***Field Sampling Plan for the
TSF-26, PM-2A Tank Contents
at Waste Area Group 1,
Operable Unit 1-10***

INEEL/EXT-03-00304
Revision 1

DATE: 4/8/03 **REVIEWER:** Donna Haney, plan author, response to EPA comments

Figure 1-2. Views of Test Area North TSF-26 PM-2A tanks.

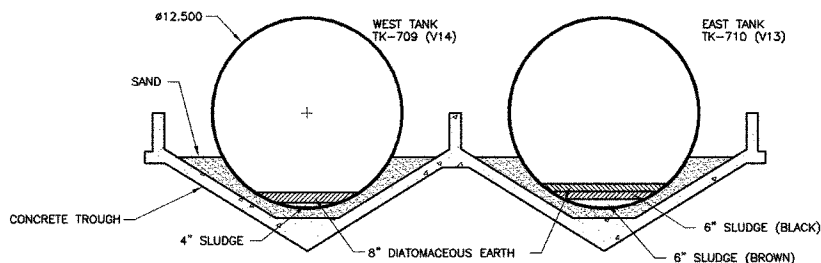
ITEM NUMBER	SECTION NUMBER	PAGE NUMBER	COMMENT		RESOLUTION
2	Section 4.1.6, 1 st full para	19	First EPA questions the use of "grid" vs. "row." Grid implies some vertical or y axis. The text indicates, and is supported by the figure on the next page, that the sampling is being done along 5 equally spaced rows. Also, it is not clear what purpose the use of a random numbers table to select the starting point for sampling. One could just as easily make the case that sampling next to the tank ends is not preferred and that the sampling locations were moved in an equal distance from the walls and then the distance between these end points was divided equally to locate the additional three sampling locations. This sampling grid does not appear to be very random.		No change. Section 9 of EPA's SW-846 "Test Methods for Evaluating Solid Waste" specifically refers to the systematic random sampling approach sections as "grids" when a random numbers table is used. The rows are evenly spaced because that is how systematic random sampling designs are applied to waste which may exhibit variation from the "random" starting point to the end of the area of concern. The starting grid was chosen from a random numbers table. Systematic random sampling is an EPA-approved type of probability sampling in which the first unit to be collected from a population is randomly selected, but all subsequent units are taken at fixed space intervals. We considered this more defensible and precise than simple random sampling since sample locations are distributed more evenly over the population. Systematic random allows coverage of the tanks from end to end and is defensible as the contents are essentially random or contain, at most, modest stratification.
